Urgent Field Safety Notice Product Correction

Product Name	List Number	Serial Number	UDI
Mixer	09D59-01 09D59-02 09D59-03	All	Not applicable

This Product Correction letter is to inform you of an issue with the ARCHITECT c Systems Mixer (LN 09D59-01, 09D59-02, and 09D59-03). There is the potential for the mixer blade, attached to the mixer with a screw and nut, to separate from the mixer. The missing mixer blade will result in inadequate mixing of the reaction mixtures leading to potential incorrect results (failed assay calibration, Quality Control (QC) out of range, and/or incorrect patient results). The impact on the test result may vary depending on the assay being performed and the viscosity of the patient sample.

Appendix A: Mixer Inspection Procedure

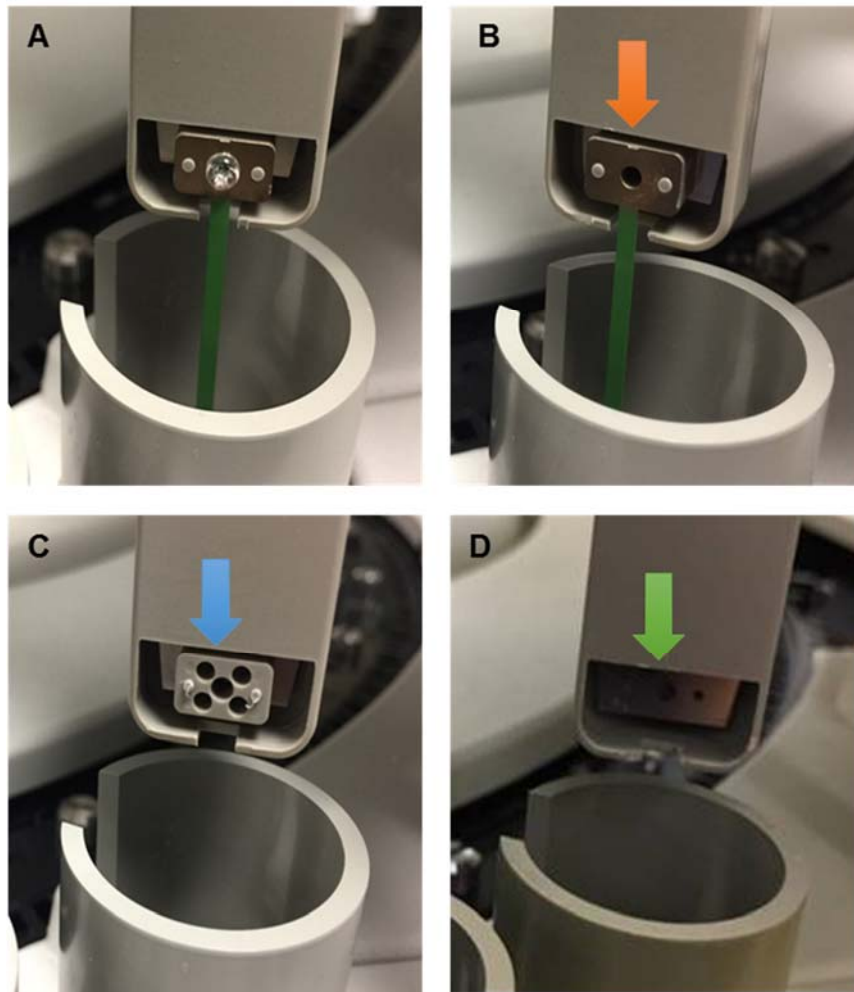
To inspect each mixer, open the rear cover of the processing module and inspect the mixer. Verify the mixer blade and screw is present.

The following pictures show a A) normal mixer B) mixer missing the mixer screw (orange arrow pointing to missing screw), C) missing mixer blade with spacer shim present (blue arrow pointing to missing mixer blade), and D) missing mixer and spacer (green arrow pointing to missing mixer blade and spacer).

1. Replace broken mixer. Refer to *Replace the Mixer (c4000, c8000, c16000)*¹.
2. Replace the cuvette dry tip. Refer to *Replace the cuvette dry tip (c4000, c8000, c16000)*¹.
3. Follow the instructions in **Appendix C** to inspect all cuvettes to ensure that the screw or nut did not fall into an individual cuvette.

Appendix D: Additional Precautions for Weekly procedure *6021 Clean Mixers*¹:

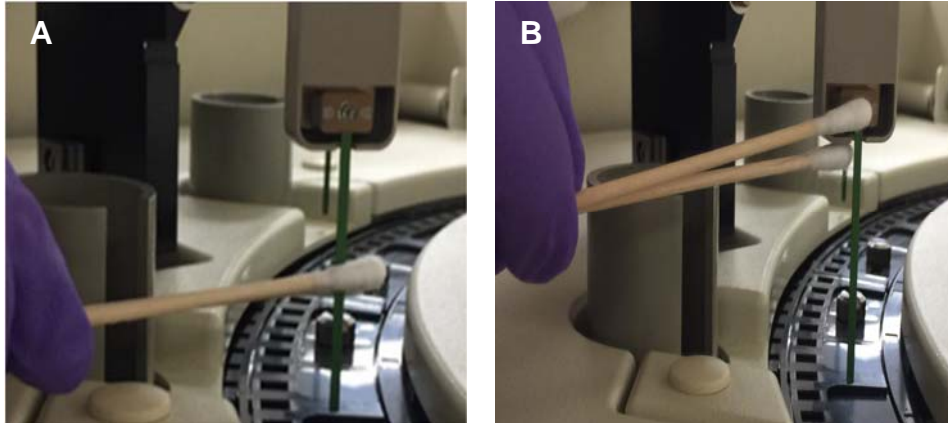
When performing weekly maintenance procedure *6021 Clean Mixers*¹, it is recommended to not let the mixer screw and 70% isopropyl alcohol come in direct contact.

The below pictures show A) the proper cleaning of the mixer and B) improper contact of the 70% isopropyl alcohol with the mixer screw.
